**Skilled Nursing Care / Mental Health Unit /
HIV – AIDS Unit and Renovation of Related
Support Facilities for
ELAYN HUNT CORRECTIONAL CENTER
LA State Project No. 08-413-97B-1, Part 7**

Addendum No. Three

ADDENDUM INFORMATION CIVIL
ELAYN HUNT SKILLED NURSING FACILITY
State Project No. 08-413-97B-1, Part 7
F&T Job No. 84637

9 ENLARGED PLAN - HRDC BUILDING
 0 2'-0" 4'-0" 8'-0"
 SCALE: 1/4" = 1'-0"

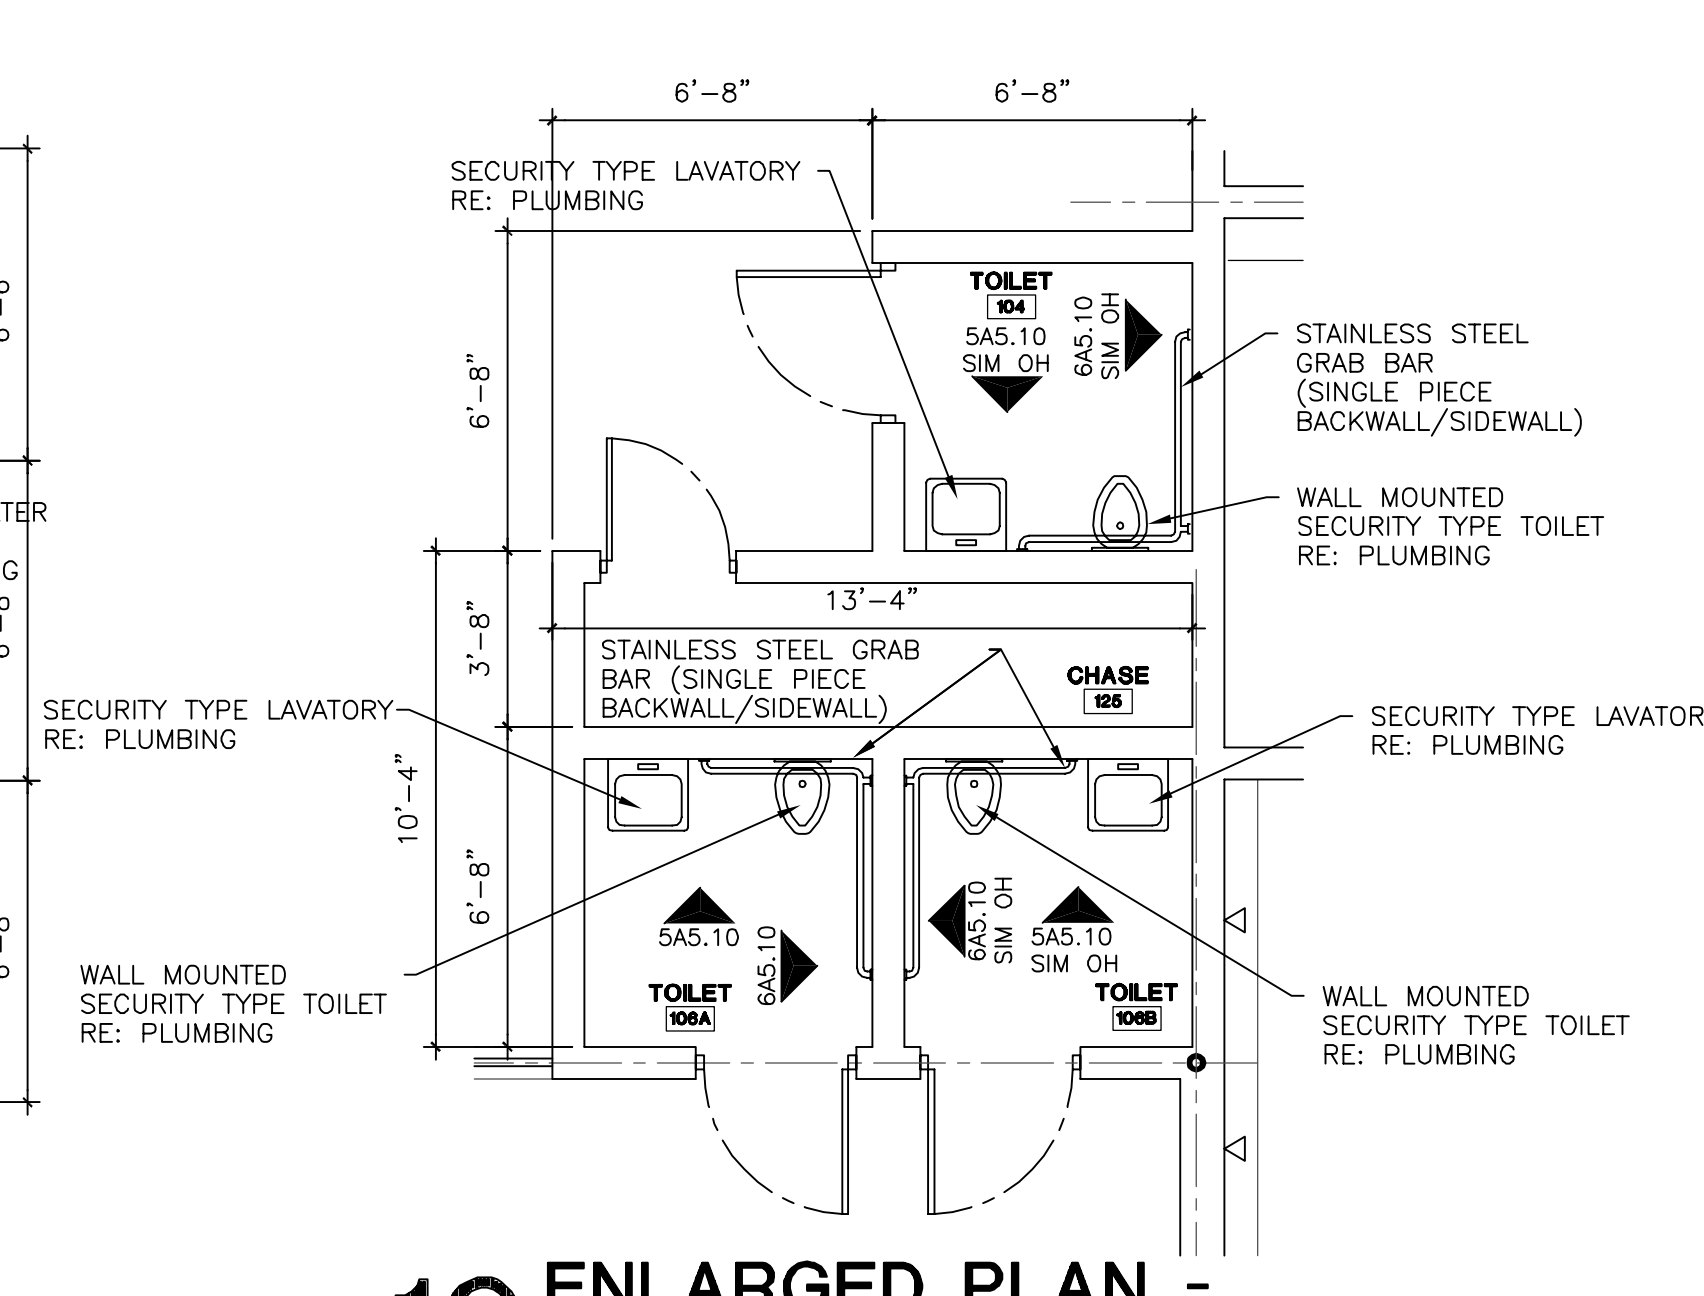
- 9) Please see attached revised A2.14 for clarification of transaction counters.

- 10) The wall height for the 4'-8" walls separating the transaction counters shall be to the underside of the metal deck.
- 11) Specification Section 07620 calls for pre-painted aluminum. This should be revised to state pre-painted steel.

PROJECT: HUNT CORRECTIONAL ADDITIONS PHASE 2
 SUBJECT: PLUMBING RISER ADDITIONS
 DRAWN BY: TAS CHECKED BY: LJ
 PROJECT NO.: 04-6401
 DATE: 06-02-05 SHEET: 1M3.12R1, 1 OF 3

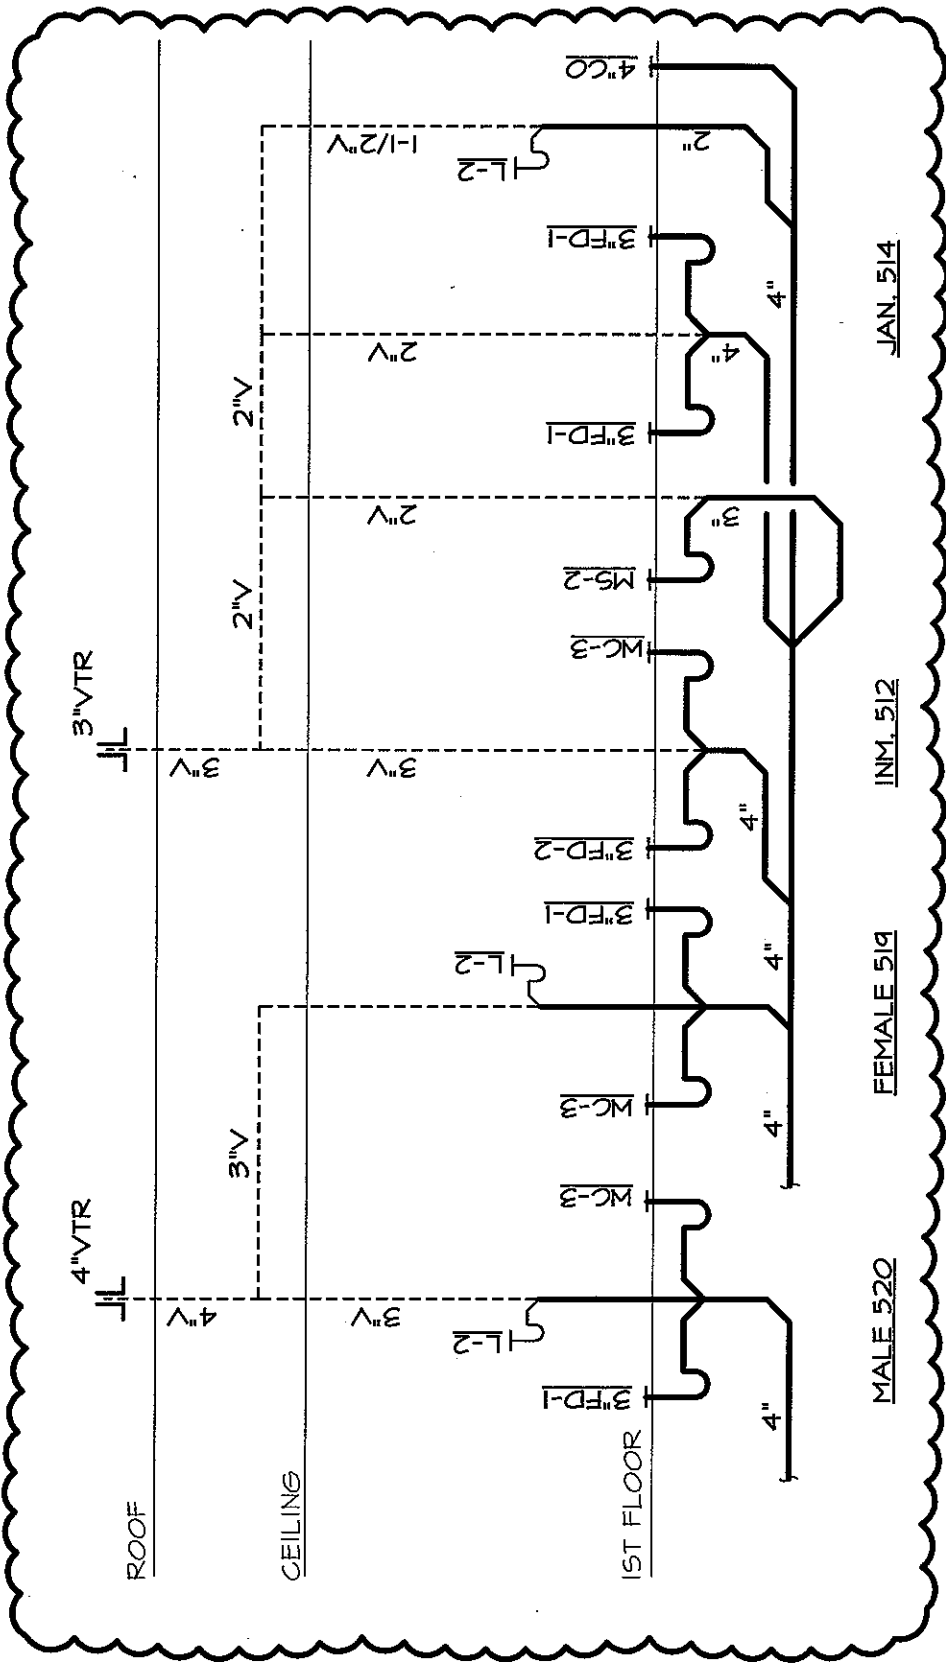
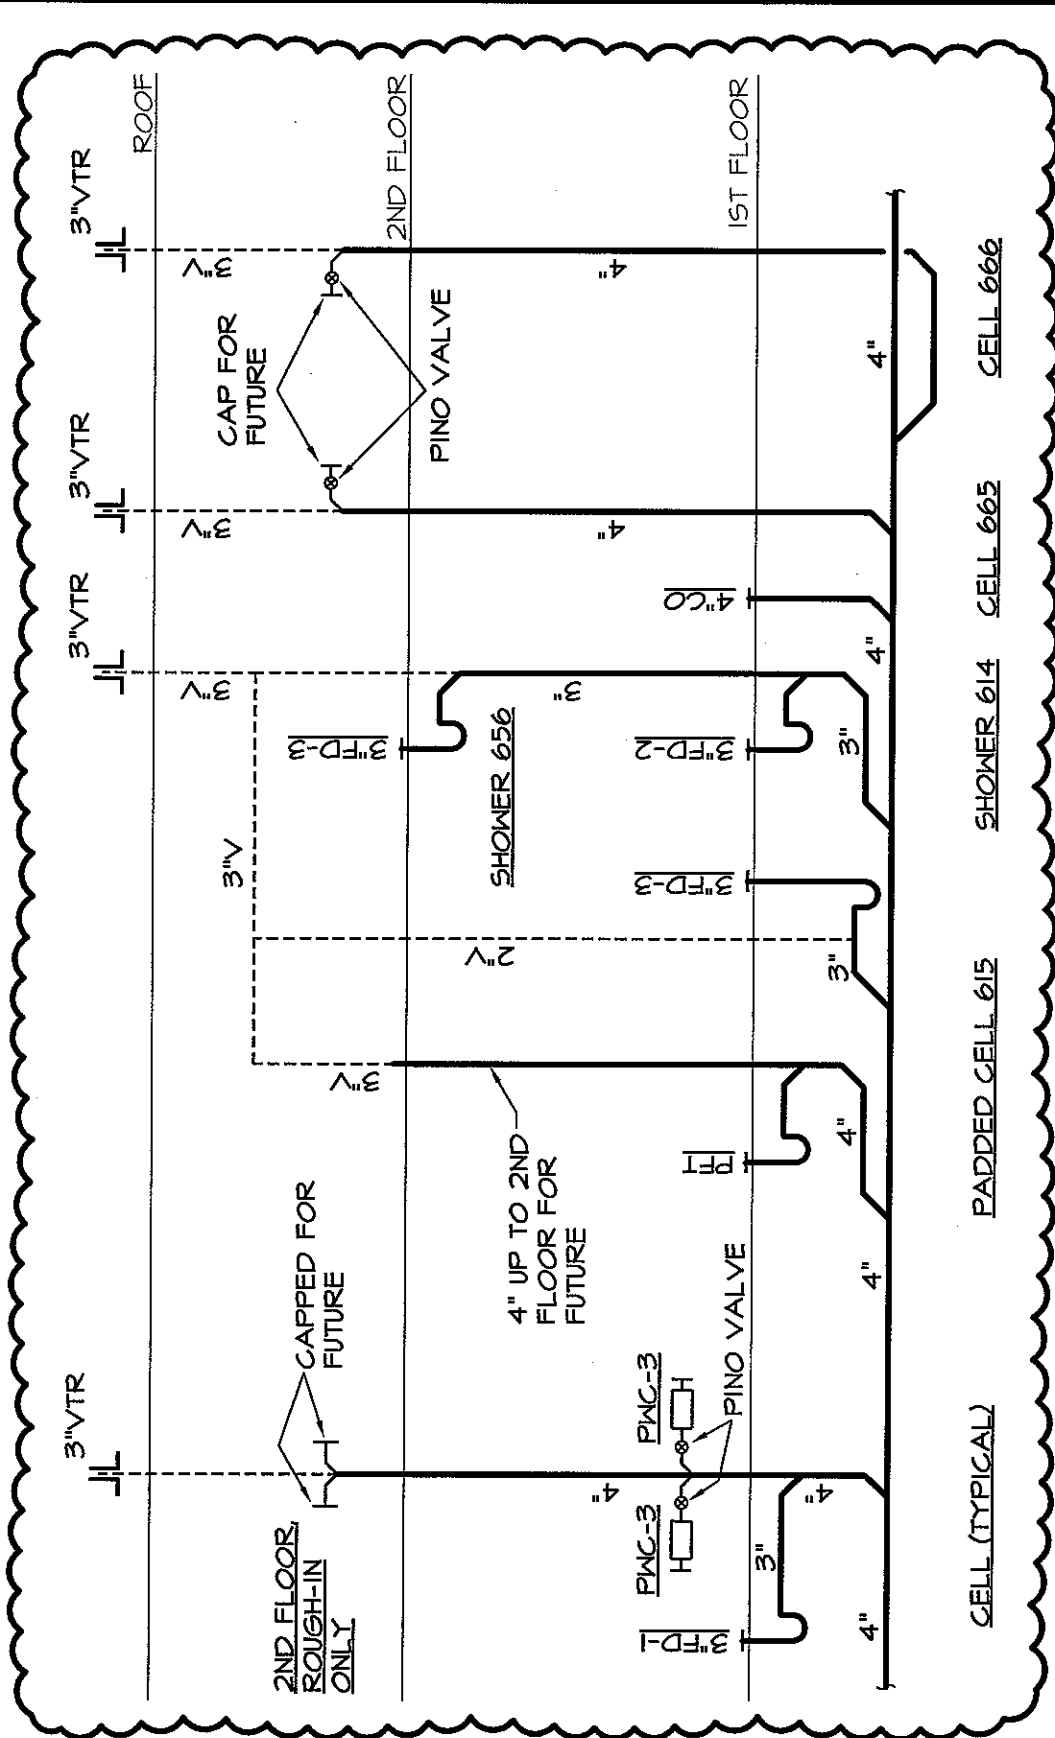
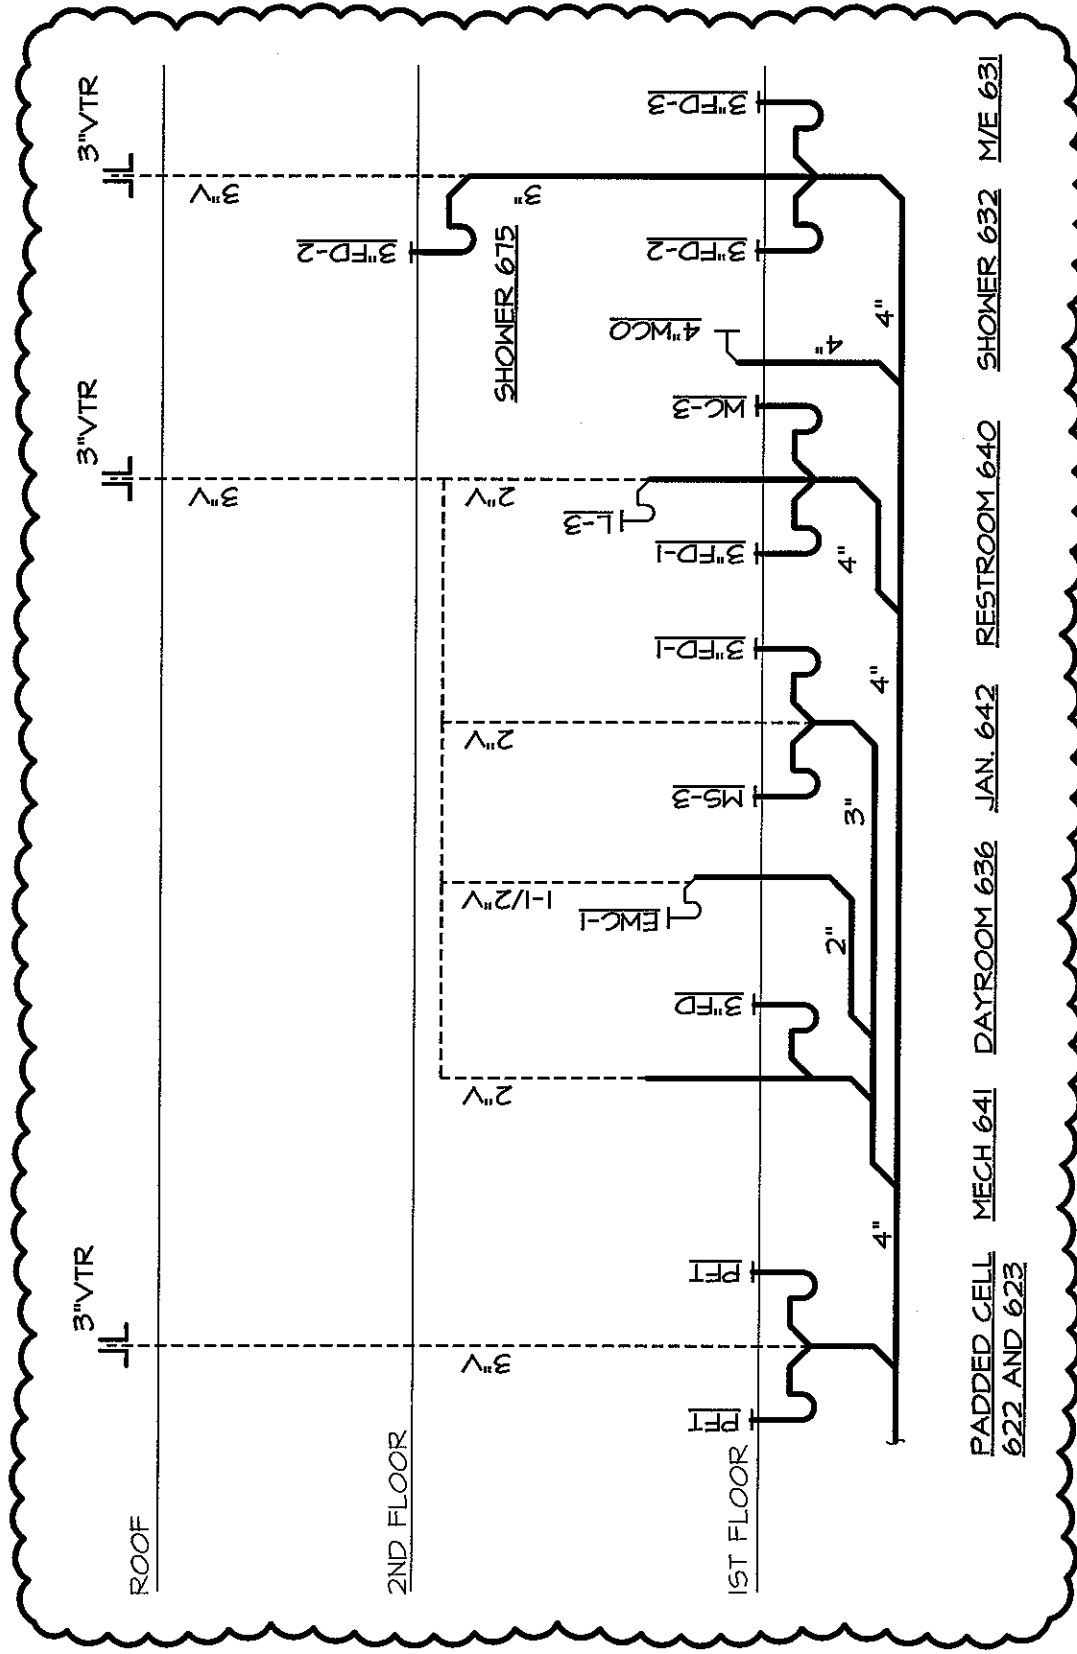
7. **Sheet M3.10, Detail 1:** Under designation and location, change EWH-1 to read GWH-1.
8. **Sheet M3.12:**
- a. Plumbing riser diagrams for Building Five are enclosed with revised drawing, Sheet M3.12R1, Sheets 1, 2 and 3.
